Independent review of Menston flooding problems

Dr Duncan W Reed

11 December 2014

Executive summary

Map 3.1: Plan of upper and middle sections of Matthew Dike

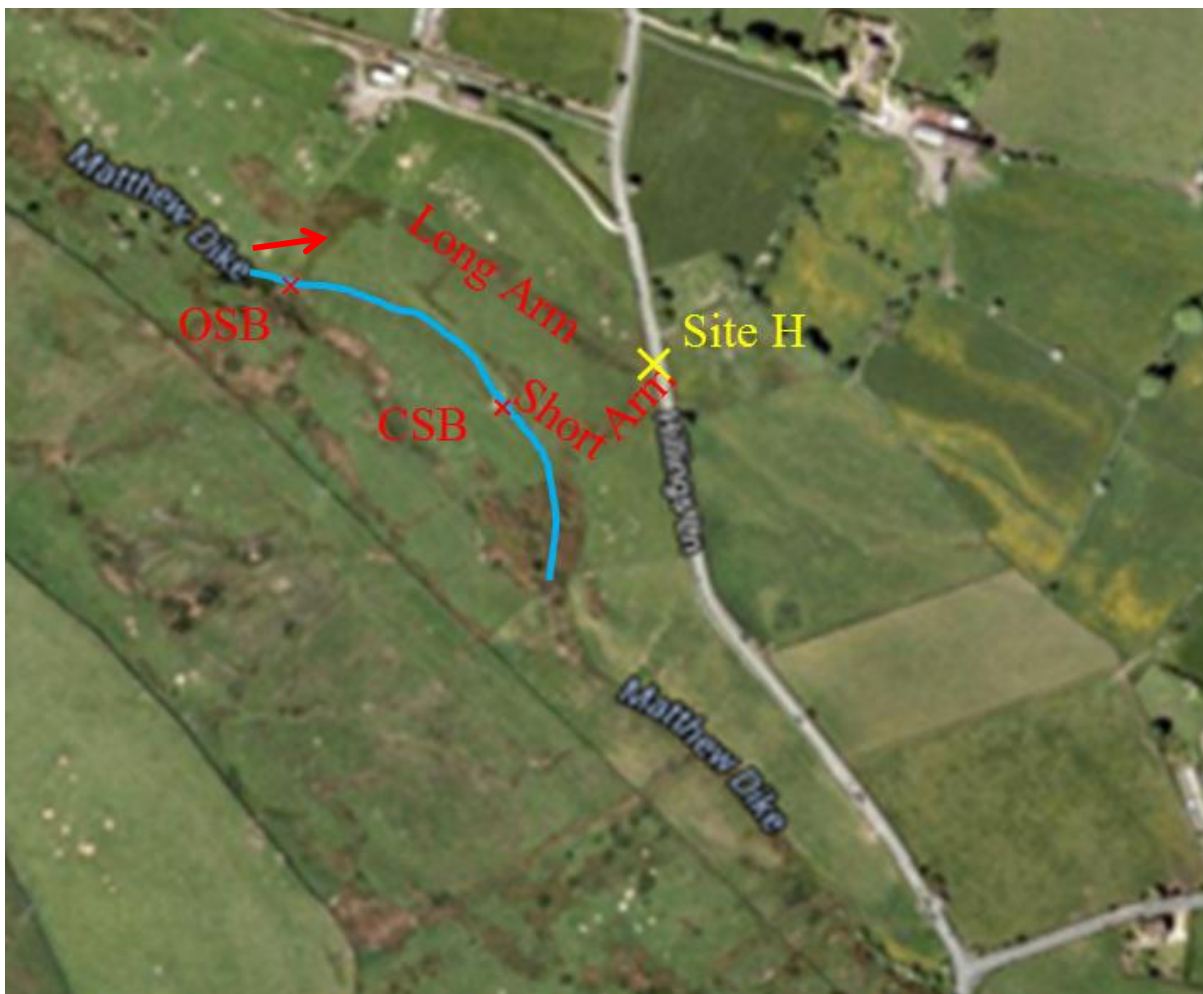
The close approach of mapped stream channels seen in Map 3.1 and the merging of modelled water levels in one of the JBA reports (see Appendix A to JDR (2014)) was one reason I was willing to take the independent review on. I expected to find that – in large flood events – floodwater in Matthew Dike over-spilled into the catchment that drains to Site H, and thence to the Derry Hill development site. It transpired that my hunch was correct although the detail was not quite as I had expected.

Figure 4.3: Annual average rates of groundwater abstraction at the HRH borehole

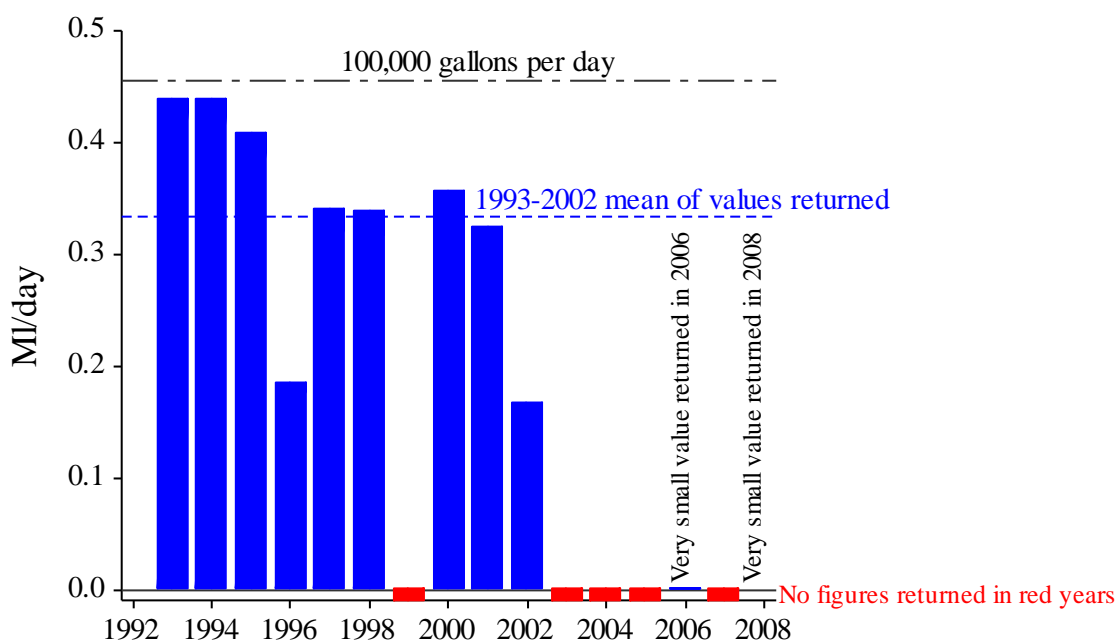
The average rate of abstraction recorded over 1993-2002 – for which records are almost complete – was 0.333 MI/day. This corresponds to the typical usage expected of say 1650 people at 200 l/head/day: confirming that the abstraction rates are realistic.

According to the statutory returns to the EA shown in Figure 4.3, groundwater abstraction under Licence Serial No. 2/27/19/172 continued until HRH closed in early 2003. Returns for 1999, 2003, 2004 and 2005 are missing. The return for 2002 shows a considerable reduction on the typical quantities returned previously. This appears consistent with running down of HRH prior to its closure in February 2003.

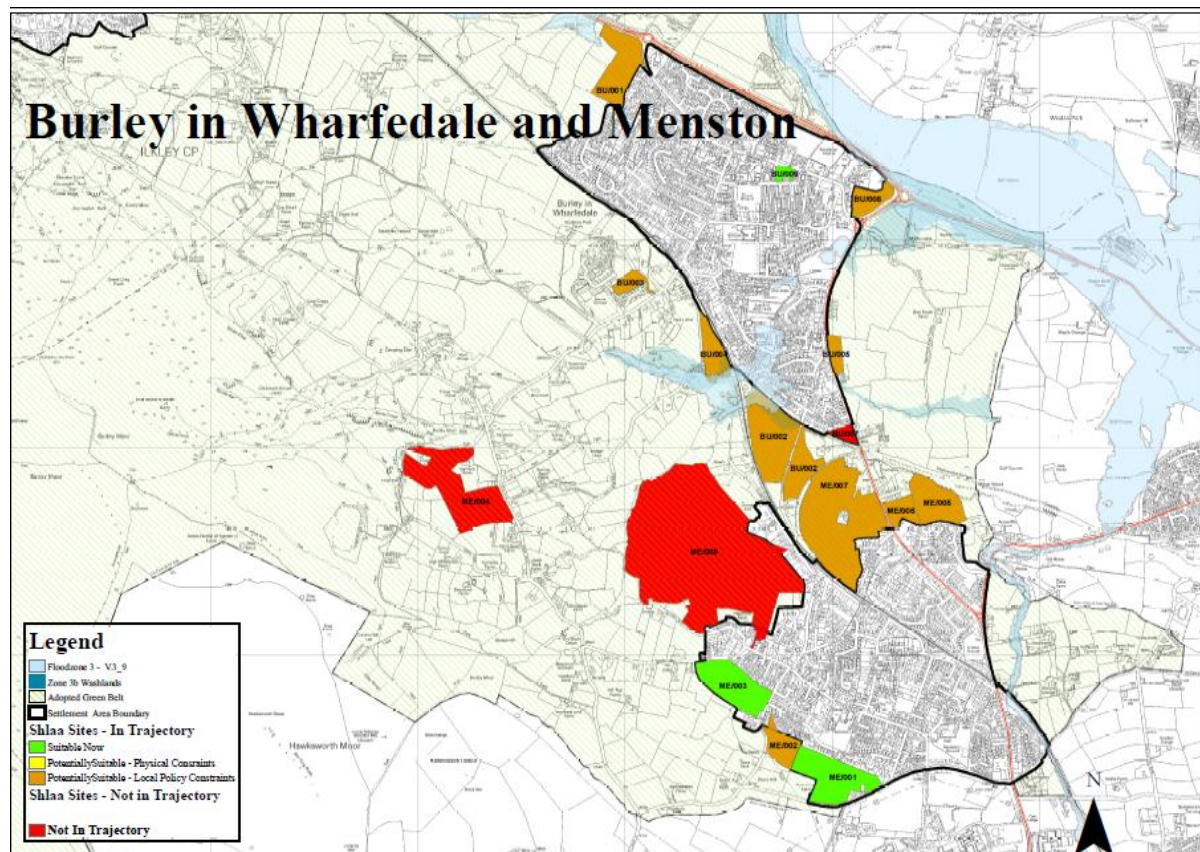
I am doubtful that the upper course of Matthew Dike can be secured against spillage into the Derry Hill catchment. To guarantee that Matthew Dike overflows to Site H *only in the most exceptional floods*, it might be necessary to line the channel and to install sediment traps where significant tributaries join from the slopes of Reva Hill. In this respect, the critical reach of Matthew Dike seems to run from about 415500 443750 to 415850 443500 over a channel length of at least 500 m.

Given the boggy ground between Matthew Dike and Matthew Dike Farmhouse, access for heavy equipment could be problematic. Any drainage improvement works would of course require landowner agreement. Canalisation of the upper course of Matthew Dike might be to the detriment of agricultural use of the land. The sediment traps would require maintenance.

A more secure approach could be to formalise flood storage on the upstream side of Site H on Hillings Lane. This might incorporate raising of the highway. Given the presence of seepage, reference to a suitably experienced geotechnical engineer or dam engineer would be required. The works would also require agreement with the landowner. The views of the Environment Agency will be important.
